2015 - 2016 Corvette: Service Bulletin: #16-NA-014: Delayed Engagement After Sitting With Engine Off

#16-NA-014: Delayed Engagement After Sitting With Engine Off - (Jun 28, 2016)

Delayed Engagement After Sitting With Engine Off

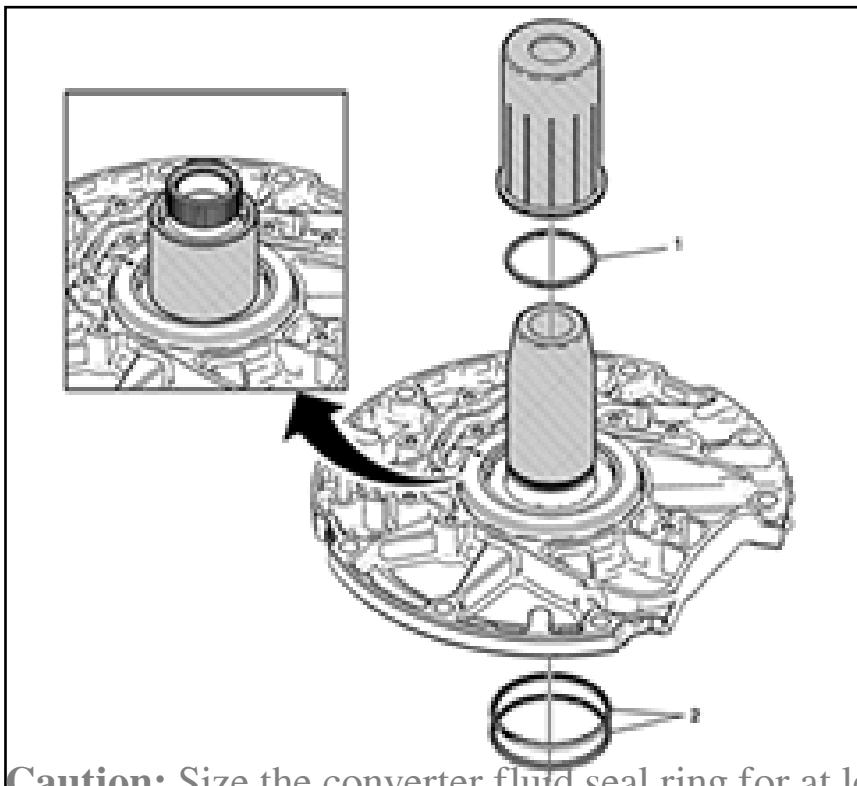
Note: The new stator shaft support assembly has a second check ball (1) added (see illustrations).

1. Remove the turbine shaft O-ring seal (1). Discard the seal.
2. Remove the nine stator shaft support bolts (2).
3. Remove the stator shaft support assembly (3).

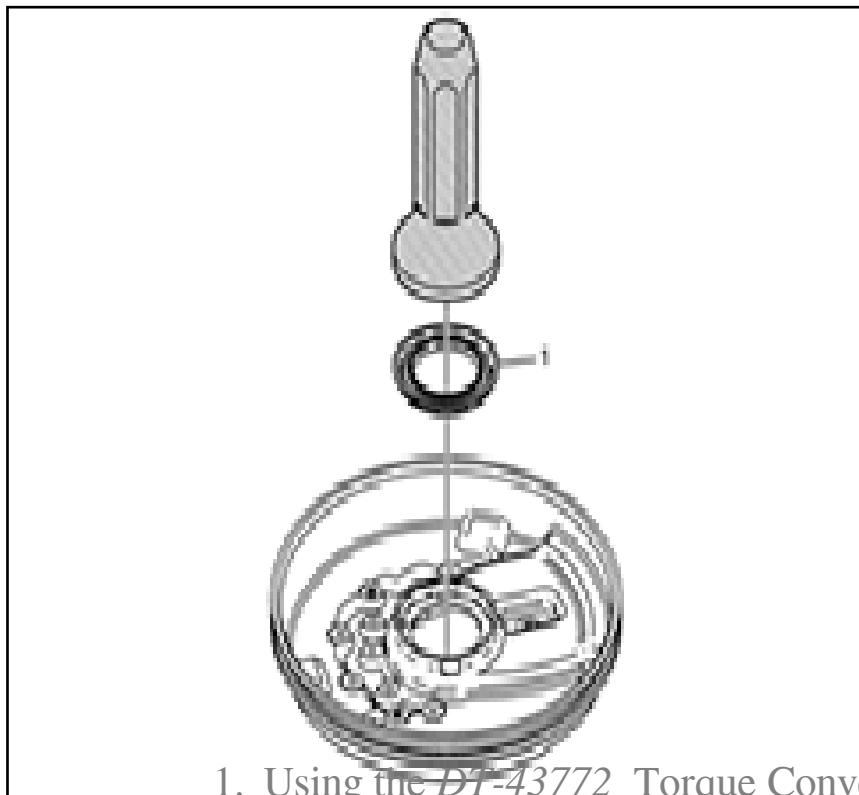
Note: The casting void has been eliminated from the underside of the cover for the 8L90 only (see illustration). The 8L45 is not required.
